LaSalle County Station, Units 1 and 2  
Facility Operating License Nos. NPF-11 and NPF-18  
NRC Docket Nos. 50-373 and 50-374

Subject: Third Six-Month Status Report in Response to March 12, 2012 Commission Order Modifying Licenses with Regard to Requirements for Mitigation Strategies for Beyond-Design-Basis External Events (Order Number EA-12-049)

**Third Six-Month Status Report for the Implementation of Order EA-12-049, Order  
Modifying Licenses with Regard to Requirements for Mitigation Strategies for Beyond-  
Design-Basis External Events**

*Use of MAAP in Support of LS Response to EA-12-049*

LA SALLE WATER SUPPLY STRATEGY (AUGUST 2014)

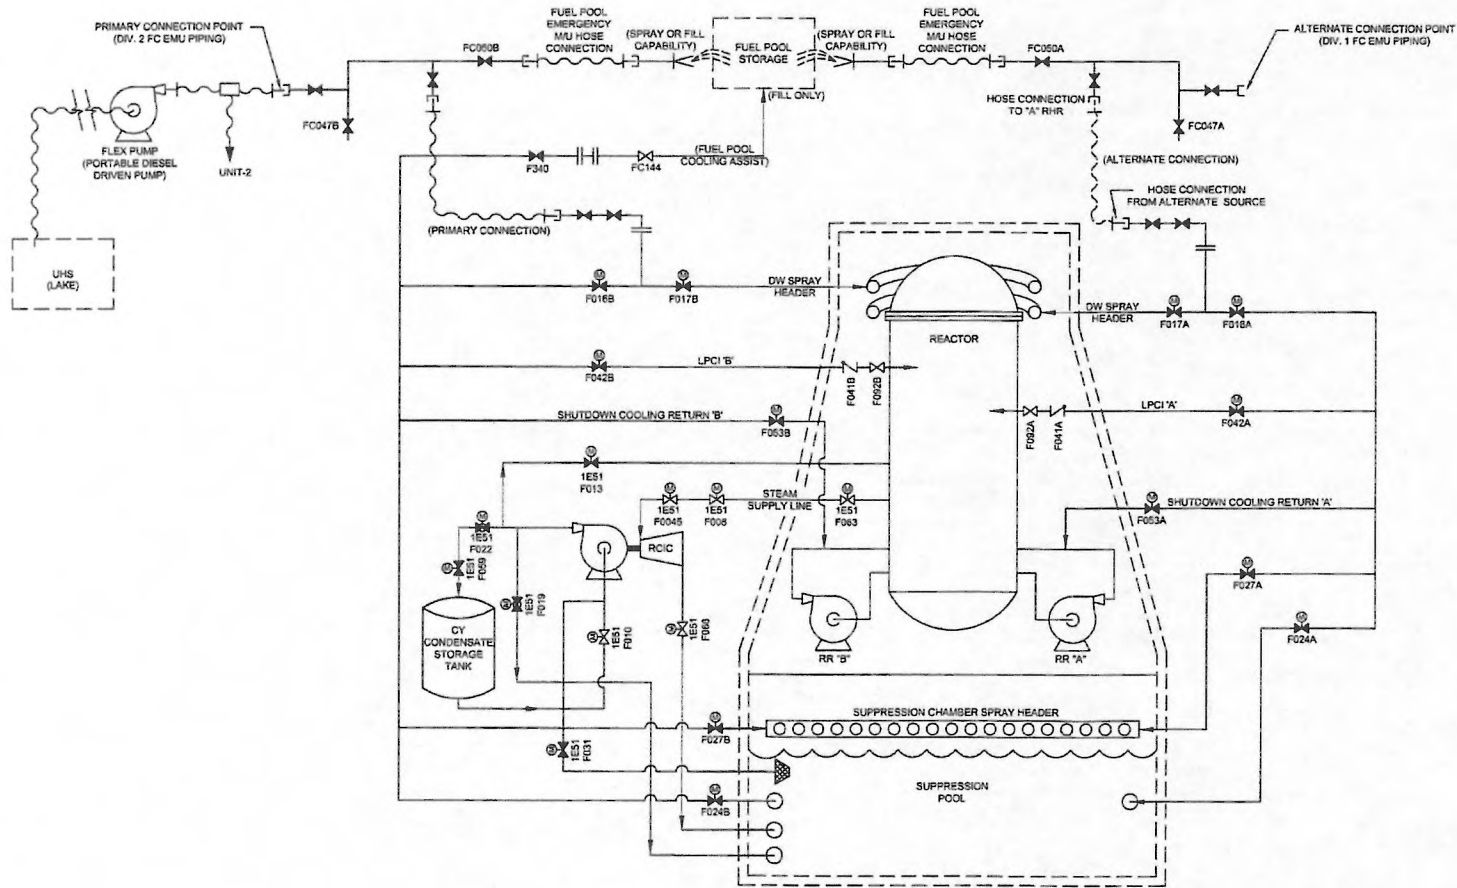
Several changes to the compliance method have been made since the February 2014 update (Ref. 7). An update call was held with members of the Nuclear Regulatory Commission on April 4, 2014, to review the current design concepts. During detailed design activities occurring since the FLEX February 2014 6-Month Update Report, several changes were made to the compliance method. The changes were discussed during the April 4, 2014 update call. Attachments 1 and 2 to this update report depict the current water and electrical supply strategies.

The change to the water supply strategy involves the elimination of the pre-staged 480 VAC FLEX pumps in the Division 2 core standby cooling system (CSCS) pump room on each unit. The revised strategy consists of an appropriately sized portable diesel-driven pump (PDDP) located at the ultimate heat sink (UHS) that provides water for both units. Two (2) FLEX PDDP's will be procured to meet the 'N+1' equipment requirements of NEI 12-06. This PDDP will either be connected to the Division 2 Fuel Pool Cooling Emergency Makeup (FC EMU) piping (Primary connection point) or to the Division 1 FC EMU piping (Alternate connection point) on each unit. The available flow paths for both connection points are depicted on Attachment 1 and include the capability to provide flow to the reactor pressure vessel, spent fuel pool and the suppression pool. This strategy change was made as a result of the detailed design work related to pre-staging the 480 VAC FLEX pumps.

Note that Attachments 1 and 2 depict the water and electrical supply strategies for Unit 1. The strategies are the same for Unit 2.

Attachment 2

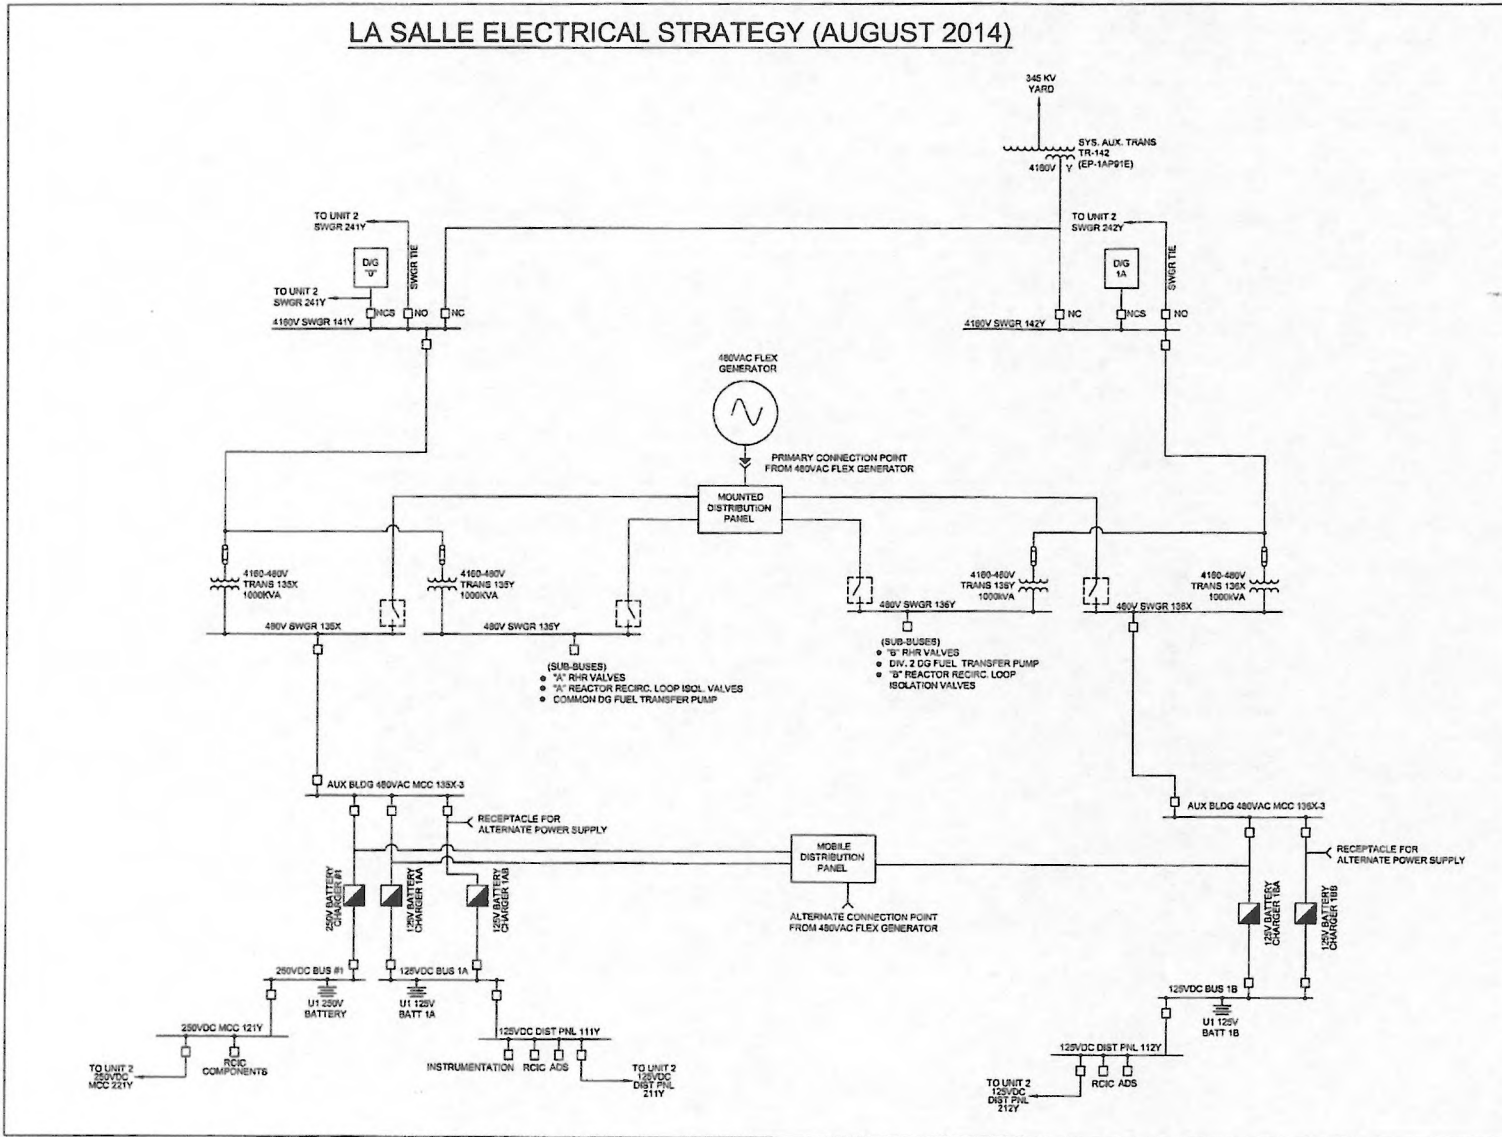
The change to the electrical supply strategy involves the elimination of the power supply need for the pre-staged 480 VAC FLEX pumps. Additionally, receptacles are shown on Attachment 2 for the spare 125VDC chargers. These receptacles are being installed to provide the capability of directly powering these chargers via the Alternate electrical supply connection strategy.

**MAAP Calculation of RPV Pressure During RPV Depressurization**

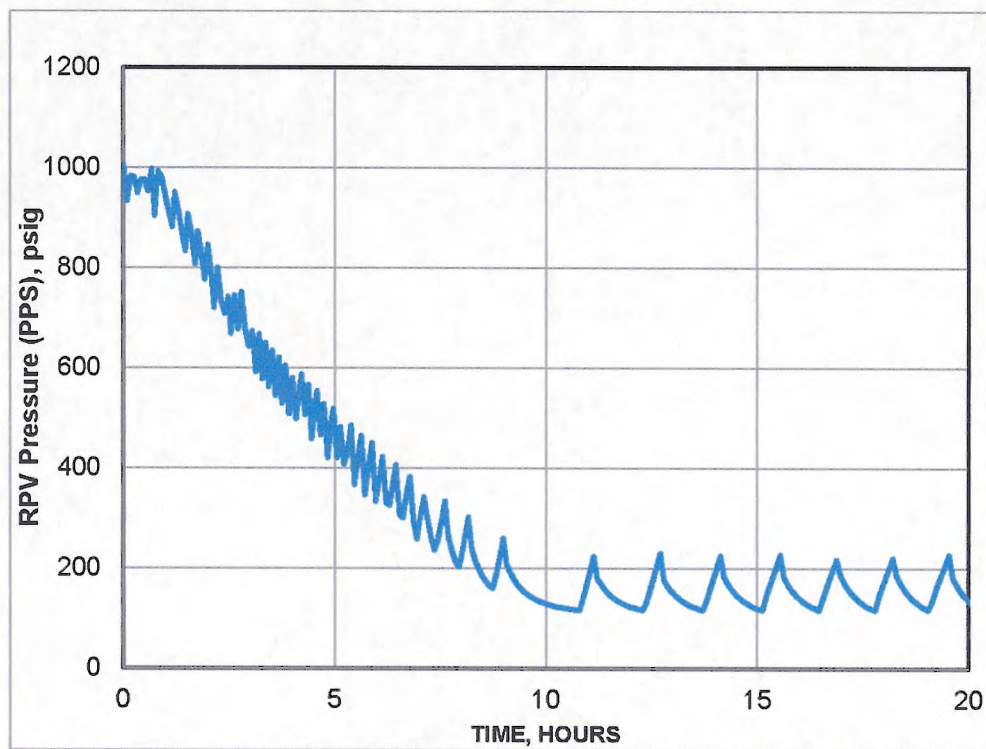
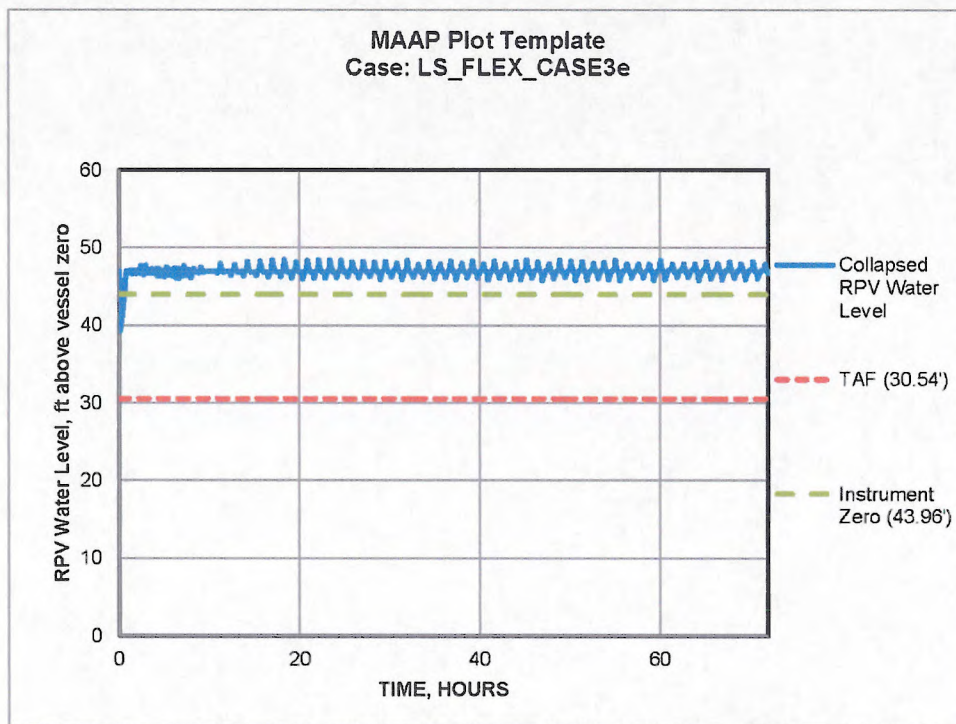
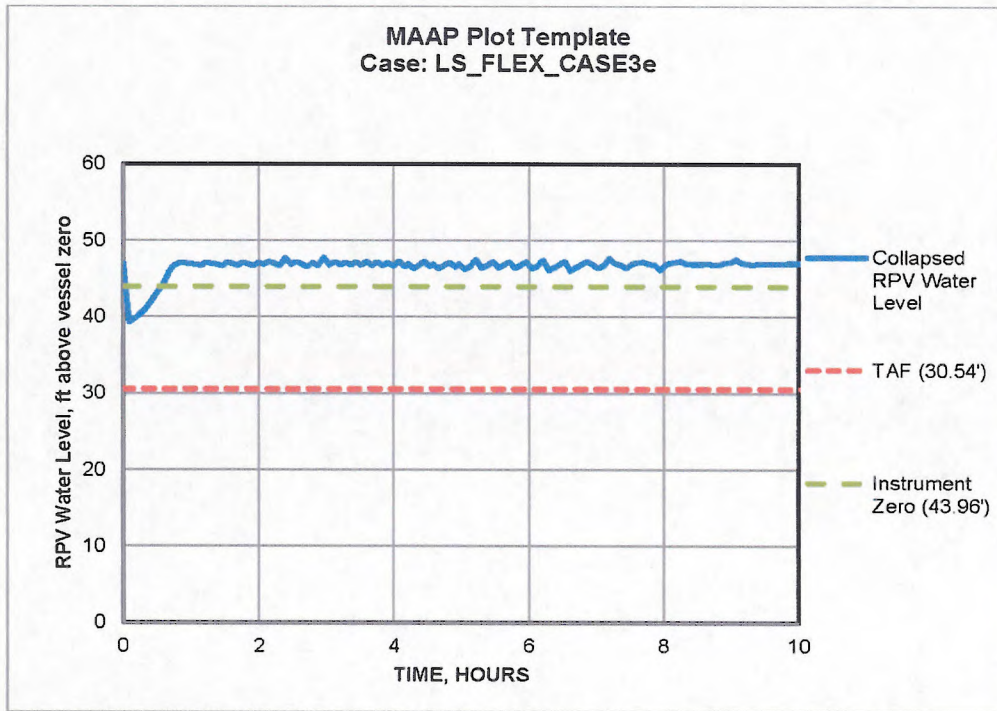
The collapsed level must remain above Top of Active Fuel (TAF) and the cool down rate must be within Technical Specification limits.

Attachment 1A of the LaSalle Integrated Plan (Feb. 2013) states that the operators would commence a cooldown of the RPV at 20 min at a rate of 20°F/hr which is within the Technical Specifications limit of 100°F/hr. The following plot of the RPV pressure from the MAAP4 analysis confirms this cooldown rate for the supporting MAAP4 calculation was modeled correctly.

For the representative MAAP4 run (Case 3.e), the collapsed RPV water level inside the shroud remains above Top of Active Fuel (TAF) for the duration of the analysis. The plots below shows that the lowest RPV water level, calculated by MAAP4, is approximately 60" (5') below instrument zero<sup>(1)</sup>. TAF is located at -161" (-13.42') relative to instrument zero. As shown in the following plots, the collapsed RPV water level remains at least 8' above TAF for the duration of the analysis.

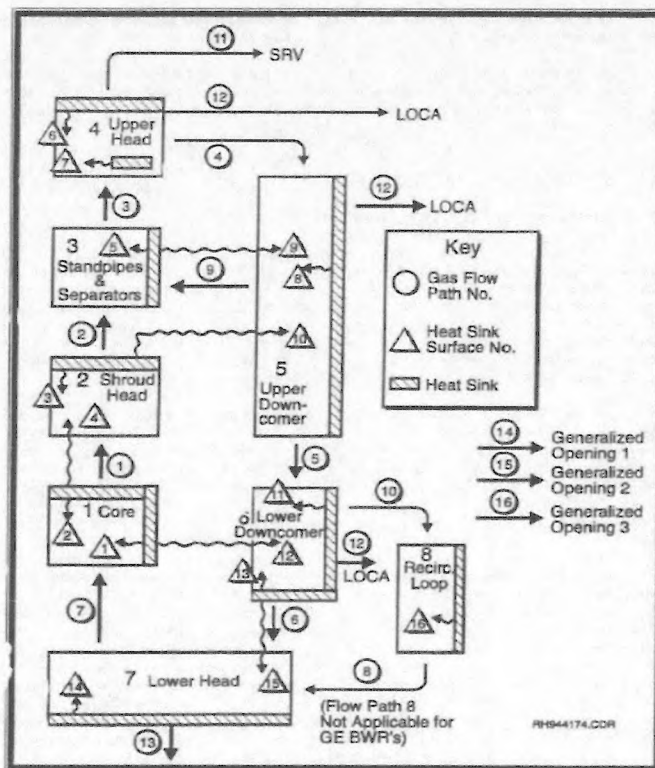
In using MAAP4, the licensee must identify and justify the subset of key modeling parameters cited from Tables 4-1 through 4-6 of the "MAAP4 Application Guidance, Desktop Reference for Using MAAP4 Software, Revision 2" (Electric Power Research Institute Report 1020236) [4]. This should include response at a plant-specific level regarding specific coding options and parameter choices for key models that would be expected to substantially affect the ELAP analysis performed for that licensee's plant. Although some suggested key phenomena are identified below, other parameters considered important in the simulation of the ELAP event by the vendor / licensee should also be included.

- a. The reactor vessel nodalization is fixed by the MAAP code and cannot be altered by the user, with the exception of the detailed core nodalization. The LaSalle MAAP 4.0.5 Parameter File divides the core region into 5 equal volume radial regions and 13 axial regions. The axial nodalization represents 10 equal-sized fueled nodes, 1 unfueled node at the top, and 2 unfueled nodes at the bottom. The LaSalle MAAP 4.0.5 Parameter File is documented in LS-PSA-009, Rev. 2 [5]. The figure below, taken from the MAAP Users Manual, illustrates the vessel nodalization scheme.
